American Honda Motor Company, Inc. (AHM) appreciates the opportunity to provide comments on CARB's amendments to motor vehicle test procedures for exhaust emissions, evaporative emissions, and refueling emissions, and new requirements for certification of aftermarket conversion systems for plug-in hybrid electric vehicles.

Honda comments on

APPENDIX D PROPOSED AMENDMENTS TO THE HYBRID EXHAUST EMISSION TEST PROCEDURES, MODEL YEAR 2009 AND SUBSEQUENT

3. Page C-1, Section 3.3(a)

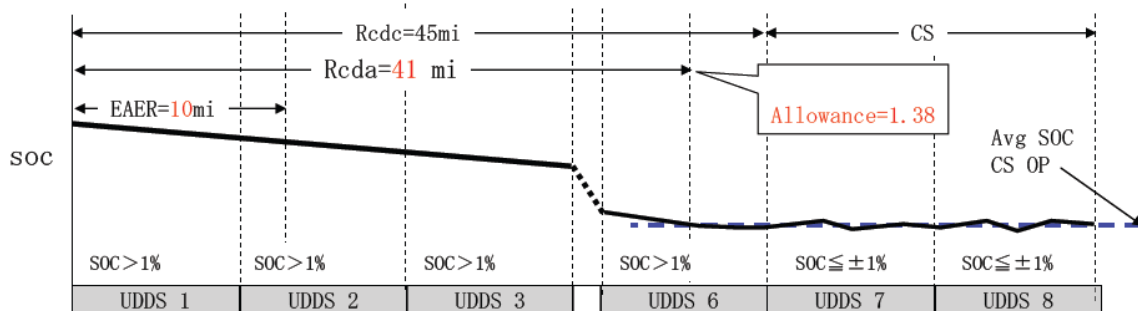
Using R_{cda} in the left column is not appropriate for several reasons:

1. R_{cda} might change from test to test depending on the two final Charge Sustaining UDDS SOC levels, resulting in test-to-test R_{cda} variability and inconsistency with EAER which is calculated by multiplying the difference between Charge-depleting and Charge-sustaining CO2 emissions ratio by R_{cdu} .
2. PHEVs employing Blended strategy could increase the R_{cda} Range to exceed 40 miles to qualify for much higher credits while its EAER is less than 40 miles. This scenario will create an unlevel playing field among PHEVs employing different strategies and the possibility of "gaming". This unfair scenario is described in the graph below.

As an example:

Vehicle A: $EAER_u = 10$ miles; $R_{cda} = 40$ miles; $UF_{R_{cda}} \rightarrow UF_{40} = 0.62$
 Zero-emission VMT Allowance = $10 \times (1 - 0.62) / 11.028 = \mathbf{0.345}$ credits.

Vehicle B: $EAER_u = 10$ miles; $R_{cda} = 41$ miles
 Zero-emission VMT Allowance = $EAER_u / 29.63 = 40 / 29.63 = \mathbf{1.35}$ credits.

The only difference between Vehicles A and B is a mere 1 mile of R_{cda} , but the difference on the credit earned is **1.005** credits! **The use of R_{cda} in the left column clearly does not work!**

Question #1: In the December 5, 2008 version, for $R_{cda} > 40$ miles, the VMT PZEV Allowance became $EAER_u$ instead of a fixed value at $EAER_{40}$ as in the October 2008 version. What was the reason behind this change?

Question #2: How was this cap $EAER_{u40} / 29.63$ determined?

Question #3: How was this equation $EAER_u \times (1 - UF_{R_{cda}}) / 14.6$ 11.028 determined?

Honda proposal:

Delete R_{cda} , use $EAER_u$ consistently in the left column as shown below:

Urban Equivalent All Electric Range (EAER)	Zero-emission VMT Allowance
$EAER_u < 10$ miles	0.0
$EAER_u \geq 10$ miles and $R_{cda} = 10$ miles to 100 40 miles	$EAER_u \times (1 - UF_{R_{cda}}) / 14.6$ <u>11.028</u>
$R_{cda} > 100$ 4 $EAER_u > 40$ mile	1.58 <u>$EAER_u / 29.63$</u>
